WILLOW PLACE
AN ADDITION TO WICHITA, SEDGWICK COUNTY, KANSAS

RE: SUB 2000-03 -- One-Step Final Plat of WILLOW PLACE ADDITION

At the regular meeting of the Subdivision Committee of the Metropolitan Area Planning Commission on Thursday, March 9, 2000, the above captioned plat was considered. The action of the Committee was to approve the final plat, subject to:

CASE NUMBER: SUB 2000-03 -- WILLOW PLACE ADDITION

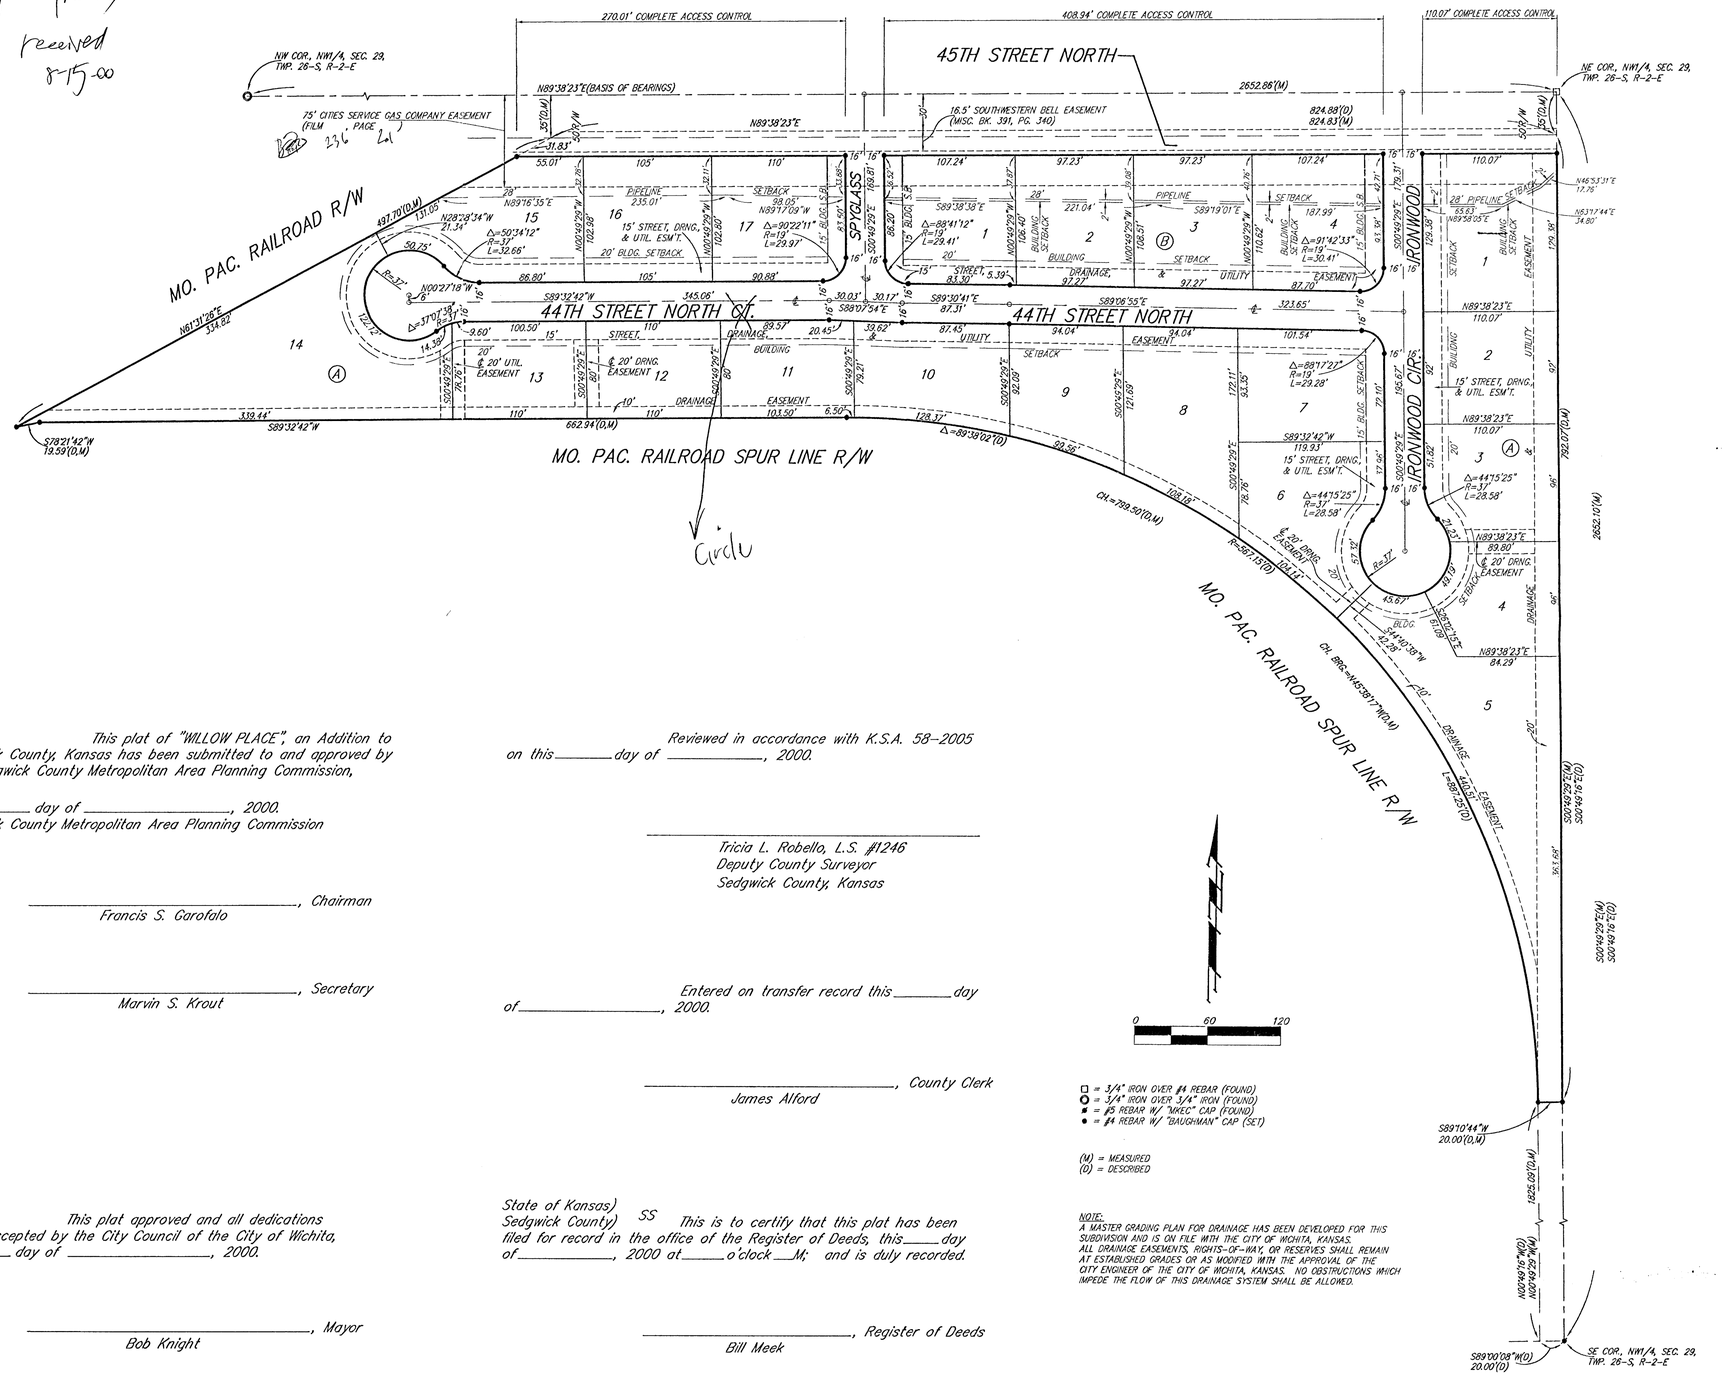
A. The Applicant shall guarantee extension of sanitary sewer and City water. City Engineering needs to comment on the need for additional guarantees or easements.

C. City Engineering needs to comment on the status of the applicant's drainage plan. *The drainage plan is approved. A guarantee is required.*

E. The plat shall dedicate complete access control along the site's frontage to 45th St. North. The access controls shall be referenced in the plattor's text.

H. City Fire Department needs to comment on the acceptability of the street names. *Willowplace should be revised to 44th St. North.*

I. Since this plat proposes the platting of narrow street right-of-way with adjacent "15-foot street drainage and utility easements", a restrictive covenant shall be submitted which calls out restrictions for lot-owner use of these easements. Retaining walls and change of grade shall be prohibited within these easements as well as fences, earth berms and mass plantings.

K. The applicant's agent shall determine any setback requirements for the pipelines by researching the text of the pipeline agreements. If a setback from the pipeline easements is provided for in the pipeline easement agreements, it shall be indicated on the face of the plat.

M. Block numbers need to be designated.

N. The bearing along the north section needs to be corrected.

O. Since this plat is not a replat, the surveyor's text should not include reference to KSA 12-512(b).

P. Traffic Engineering should comment on the need for improvements to 45th St. North. *No improvements are required. The location of Spyglass shall be relocated eastward between Lots 1 and 2, to increase the distance from the railroad.*

Q. City Engineering requests the addition of radii at the intersections of the internal streets.
